**ADDENDUM NO. 1
TO THE
SPECIFICATIONS AND CONTRACT DOCUMENTS**

City Project No. PNR23004

NE 3rd Avenue Trailhead Improvements

January 16, 2024

WORK REQUEST # 577055-1

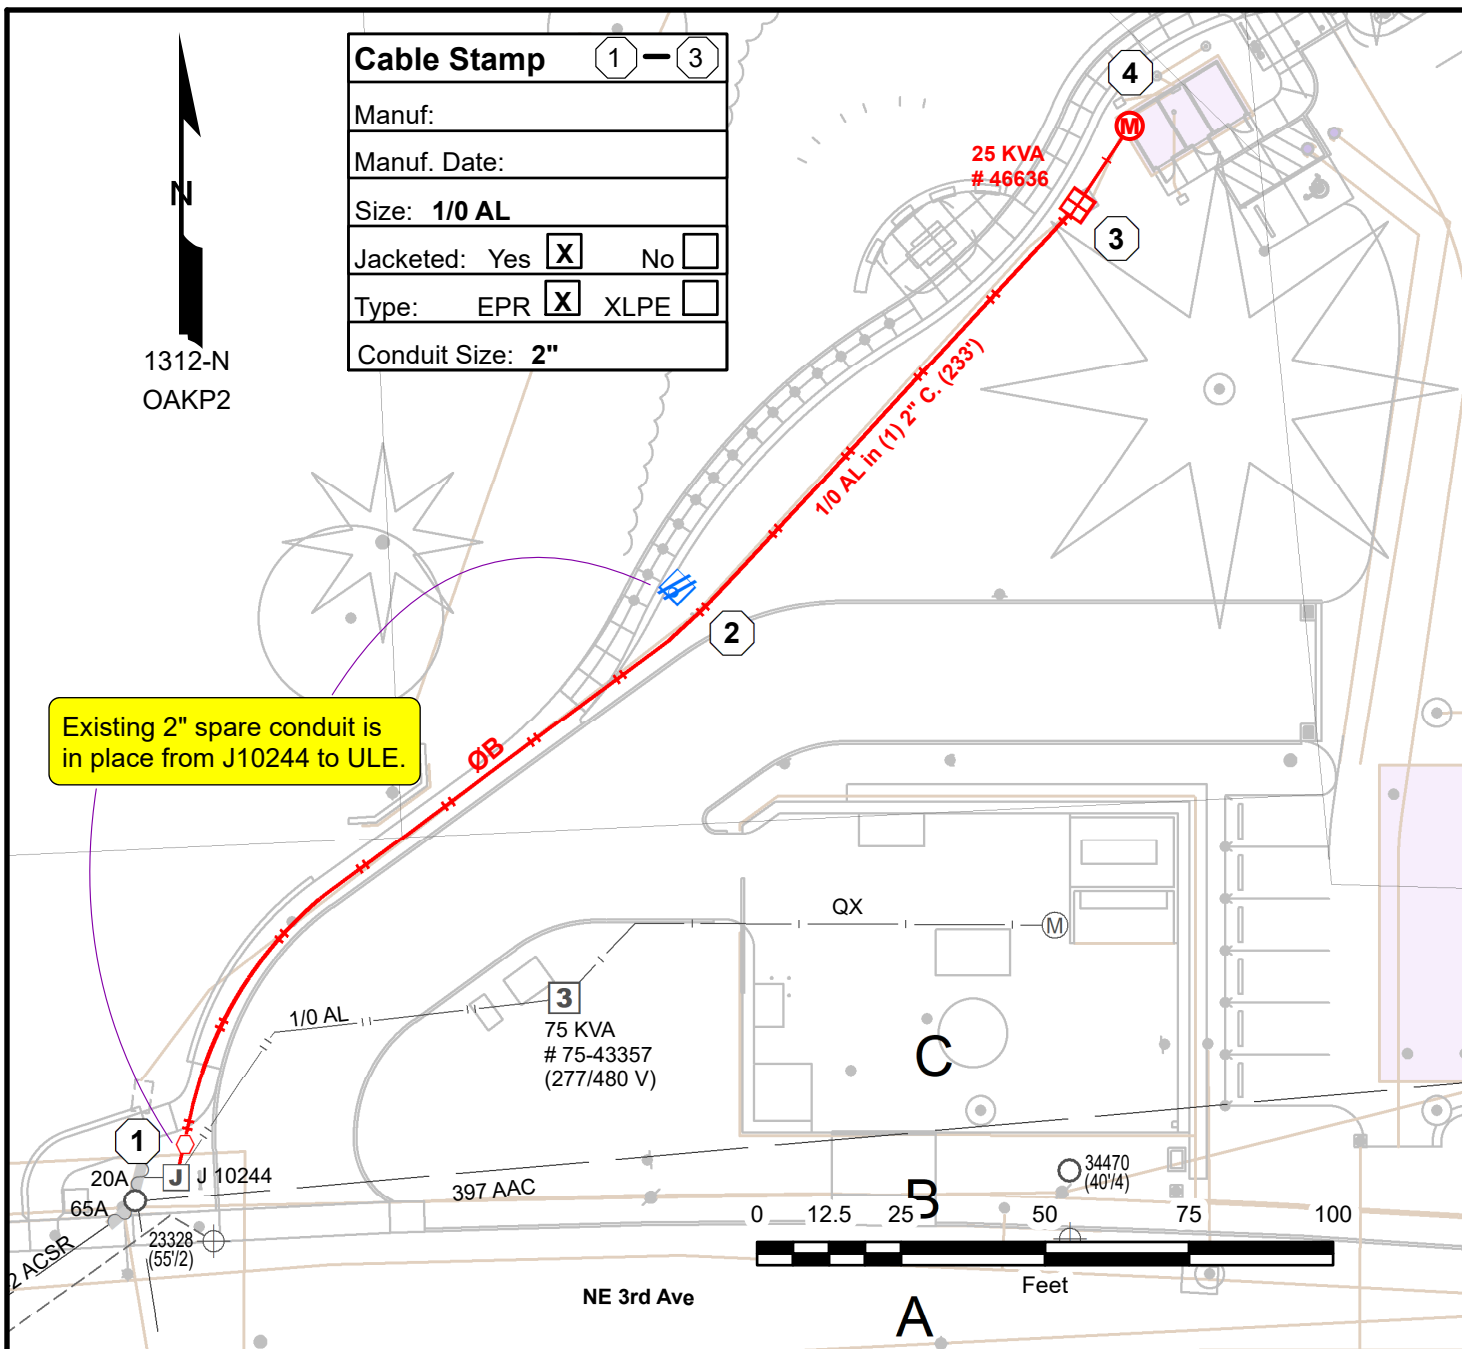
The City will pay all fees directly to Clark Public Utilities (CPU) for installation of a new pad mounted transformer to be installed by contractor. The location of the new transformer will be coordinated and finalized by the contractor, owner, and CPU at a later date. It is the responsibility of the contractor to coordinate work items with CPU during construction.

577055-1MAPS.pdf: Clark Public Utilities design for the service connection.

- WL 1:** REQUEST CPU standby at J10244. Pull in (1) 1/0 EPR. COIL the cable inside and leave a tag for CPU.
- WL 2:** REMOVE (1) ULE (loop enclosure) and intercept (1) 2" spare PVC. MELD existing 2" PVC with new 2" PVC to extend conduit path to new XFM.

- WL 3:** PROVIDE/INSTALL a pad-mounted transformer (25kVA, 1Ø, 120/240V, per CPU spec UT2). Label the transformer# 46636. Place the XFM 2-FT back of the sidewalk; front shall face the sidewalk. Clearance to the BLDG shall be 10-FT minimum. See other clearance requirements in the diagram. MAKEUP (1) 1/0 EPR and label all cables per CPU spec UID2. LEAVE two (2) load-break elbows with sealing kits, and one (1) fault indicator for CPU.

- SPAN 2-3:** EXTEND (1) 2" PVC primary conduit from ULE to XFM 46636.
- SPAN 1-3:** PROVIDE/INSTALL (1) 1/0 AL cable (175mil w/ jacketed neutral) in (1) 2" PVC.

- WL 4:** PROVIDE/INSTALL a 4-terminal meter base **with manual block bypass** at 5-ft height above finished grade (reference B-Line part# U264 or equivalent) for 3-wire, 120/240V, 100A service. See CPU Commercial Electric Service Handbook for full set of requirements.

- SPAN 3-4:** PROVIDE/INSTALL secondary conduit/wire per NEC. Secondary conduit/wire are customer-owned and maintained.
